## RE: Westlink Industrial Estate Stage 2 [SSD-9138102] – TMAP Addendum

The purpose of this addendum is to provide an update to the original Transport Management and Accessibility Plan (TMAP) (file reference: 2056r01v04 TMAP Westlink Stage 2, Issue) for the Westlink Industrial Estate – Stage 2.

Figure 1: Warehouse Lot 6, dated 17.01.2025

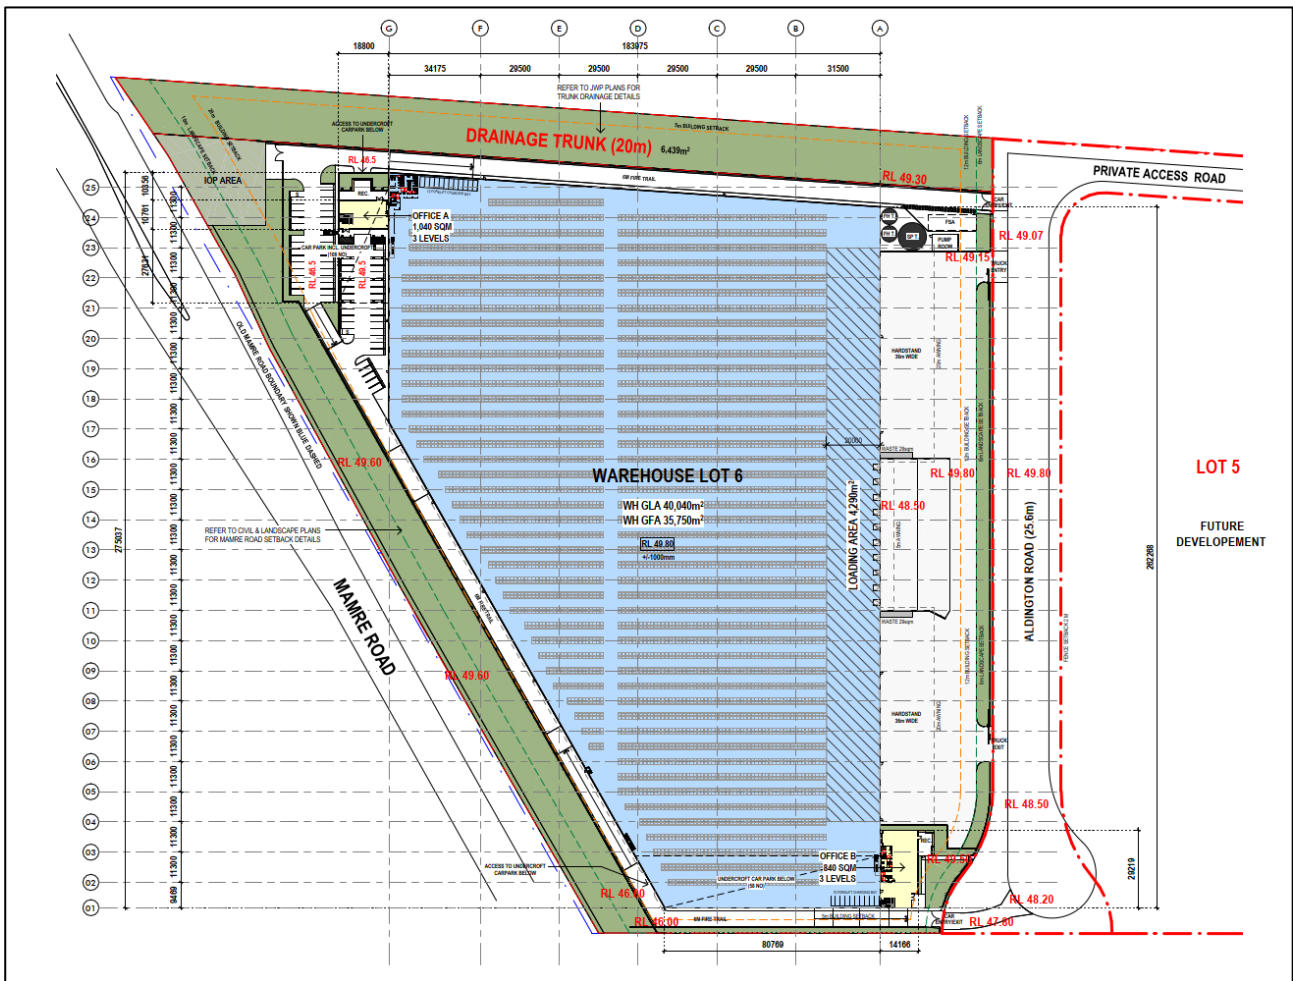
The revised proposal remains consistent with the original Transport Management and Accessibility Plan (TMAP) with the following minor updates:

- Warehouse GFA: 35,750 m<sup>2</sup>
- Office GFA: 1,740 m<sup>2</sup>
- 166 parking spaces
